Project	IEEE 802.16 Broadband Wireless Access Working Group < http://ieee802.org/16 >	
Title	Comments and further considerations for Uncoordinated Coexistence Protocol	
Date Submitted	2006-11-14	
Source(s)	<p>Jiezhen Lin Siemens Network Ltd., Beijing R&D 1# Building of SOFPA, No.8 of Dong Bei Wang Xi Lu, Haidian District, Beijing, P.R.China, 100094</p> <p>Paul Piggin NextWave Broadband Inc. 12670 High Bluff Drive San Diego CA 92130 USA</p>	<p>Voice: +86 10 6476 6914 Fax: +86 10 6473 3786 Jiezhen.lin@siemens.com</p> <p>Voice: +1 858 480 3100 Fax: +1 858 480 3105 ppiggin@nextwave.com</p>
Re:	The first Letter Ballot to IEEE P80216h_D1	
Abstract	Comments and further considerations reflects ongoing Work Group discussion on the Enhancement for uncoordinated coexistence	
Purpose	Revised comments	
Notice	This document has been prepared to assist IEEE 802.16. It is offered as a basis for discussion and is not binding on the contributing individual(s) or organization(s). The material in this document is subject to change in form and content after further study. The contributor(s) reserve(s) the right to add, amend or withdraw material contained herein.

Comments and Further Considerations fo

Suggested Revisions for section 6.4.2.4

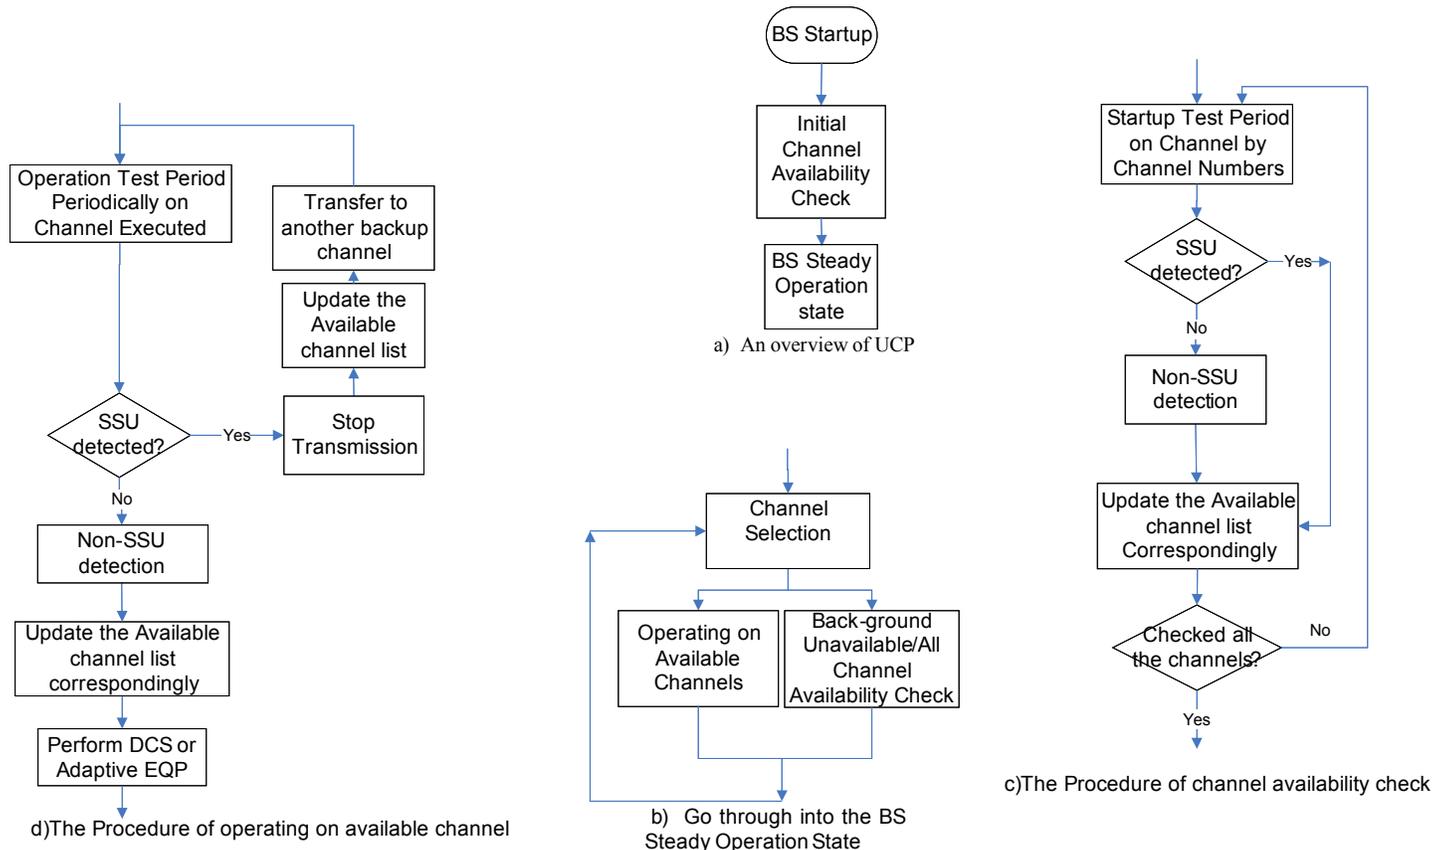
Upon system startup, the BS shall undertake perform DFS/DCS protocols, depending upon the requirements for operation given in the band, to choose a suitable ~~the~~ channel on which to operate. If the band has SSUs, the BS shall use a protocol termed in this sub clause DFS to find a channel free of SSUs; this protocol is described in sub clause 6.4.2.2. DCS shall be used to choose the *best* channels in bands that ~~are not~~ occupied by ~~a non-SSU~~; this protocol is described in sub clause 6.4.2.3.2. The definition of *best* for this purpose shall be left for vendor differentiation.

The BS shall continue to perform DFS and DCS, as required for a given band, selecting the most appropriate *physical* (frequency only component), based on the prevailing conditions and reacting to measurement and reporting from SSs. For the case SSUs are

detected on a channel then the DFS protocol shall attempt to select a new *physical* channel based on that described in 6.4.2.2. For non-SSU detection the BS shall use the DCS protocol in order to select an alternative *physical* channel or shall ~~The BS shall implement~~ use adaptive EQPs, as described in clause 6.4.3.3, to ensure other systems that are detected have an opportunity to transmit. The BS shall require measurement and reporting from the SSs per the DFS/DCS protocol, and move to a better channel should one come available. If systems other than ~~other 802.16 systems and~~ SSUs are may be present in the channel, the BS shall use the listen-before-talk (LBT) protocol of 6.4.3.5 to avoid scheduling a frame when another system is transmitting on the channel.
